CCK-2729-24
UKHC Parking Structure #8 Expansion BP#01
Project# 2565.0
ADDENDUM #5
07/13/2023

#### **PARKING STRUCTURE 8 EXPANSION**

### **ITEM NO. 5.01**

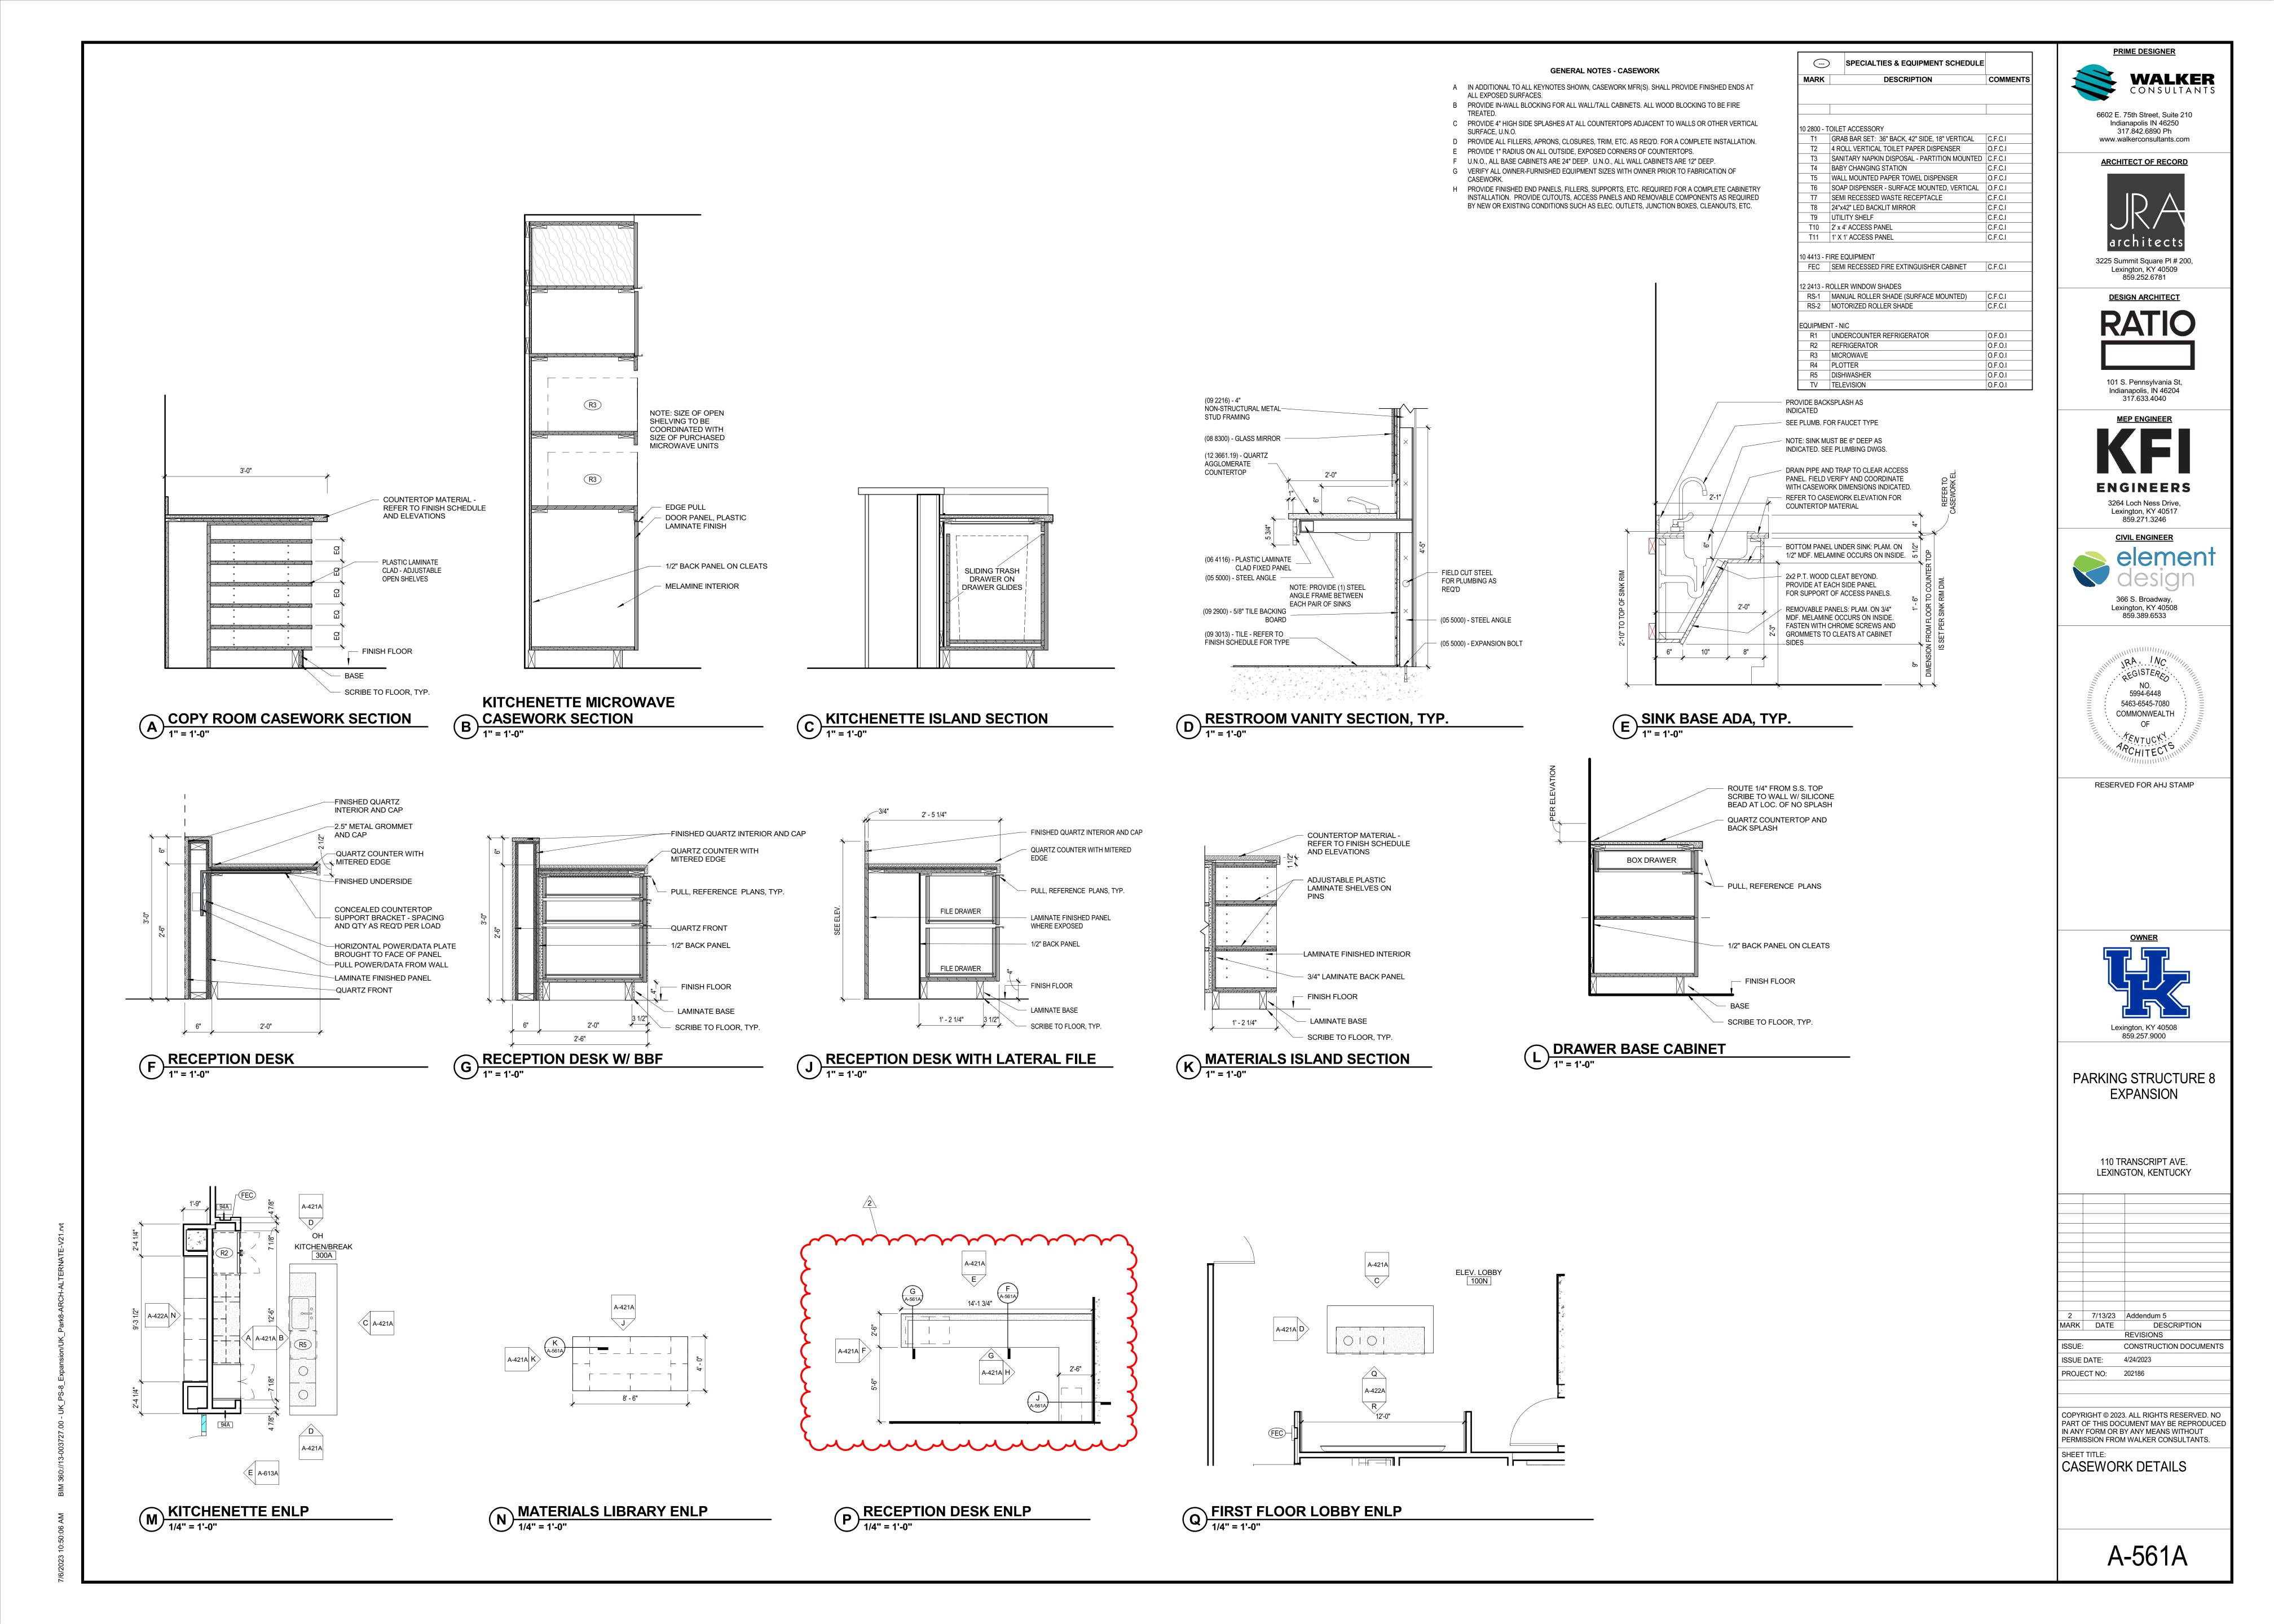
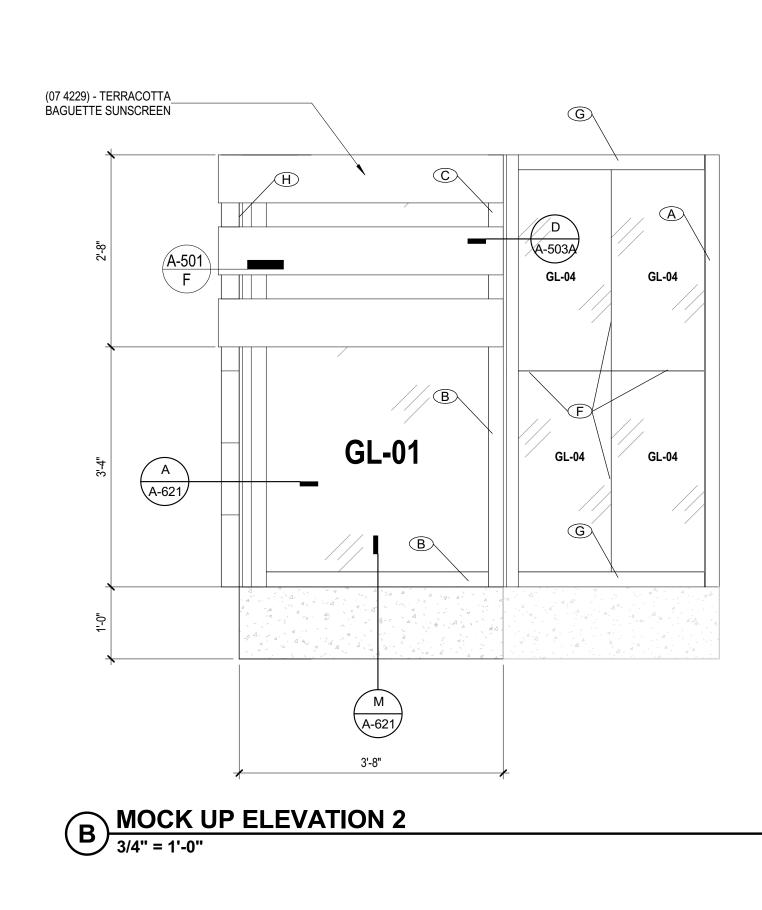
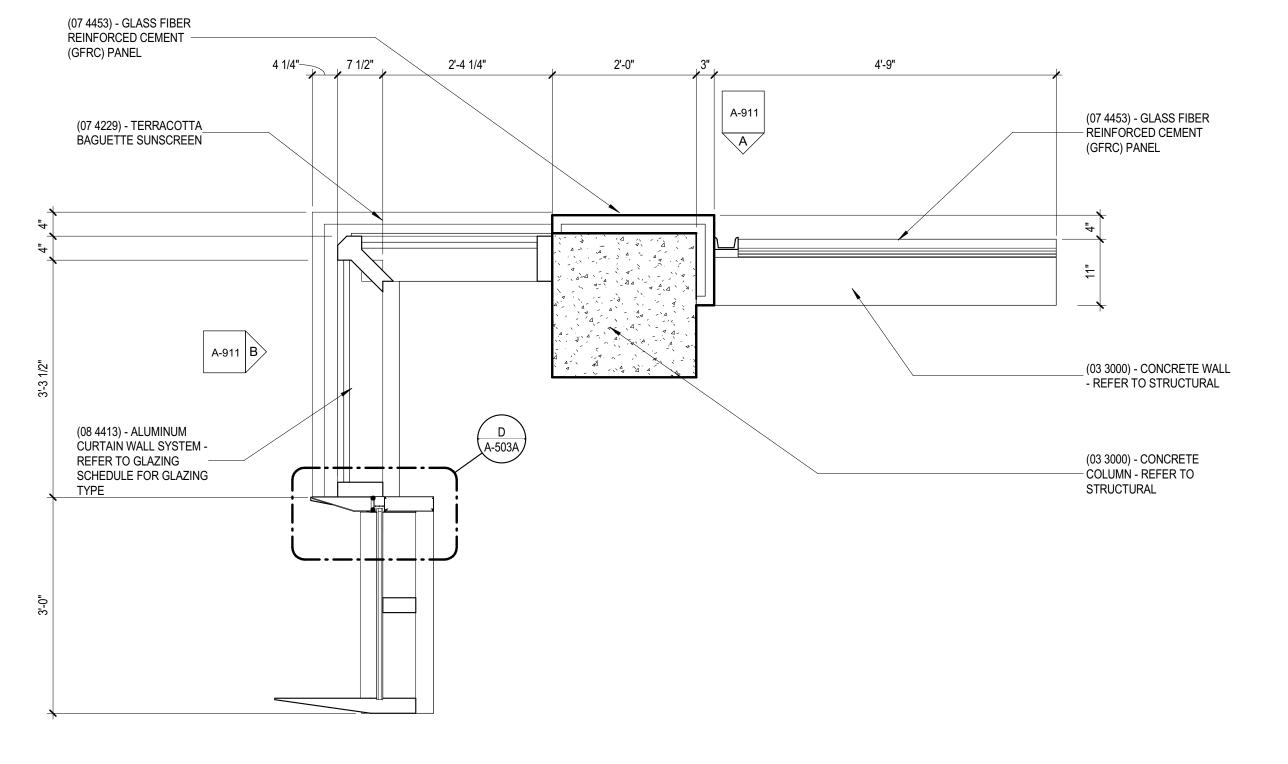
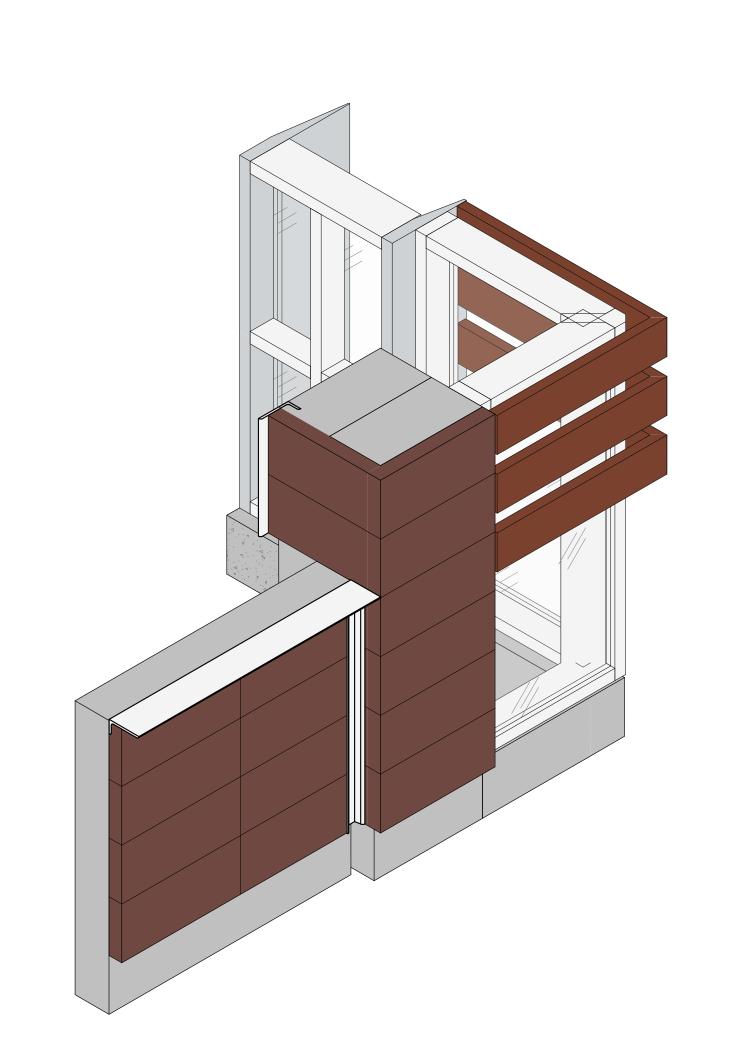
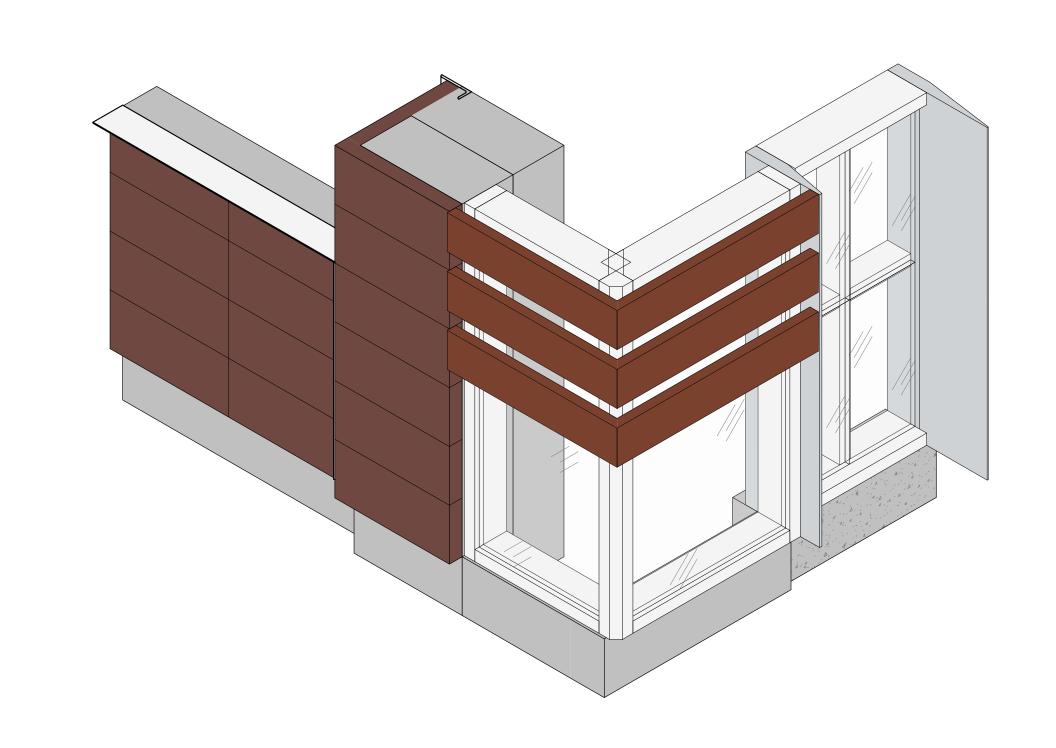
Refer to newly issued drawing sheet A-911. This sheet details the requirements for a mock-up panel. Refer to the site plan for location. This requirement supersedes the requirement for the panel mockup shown on drawing sheet A-212.
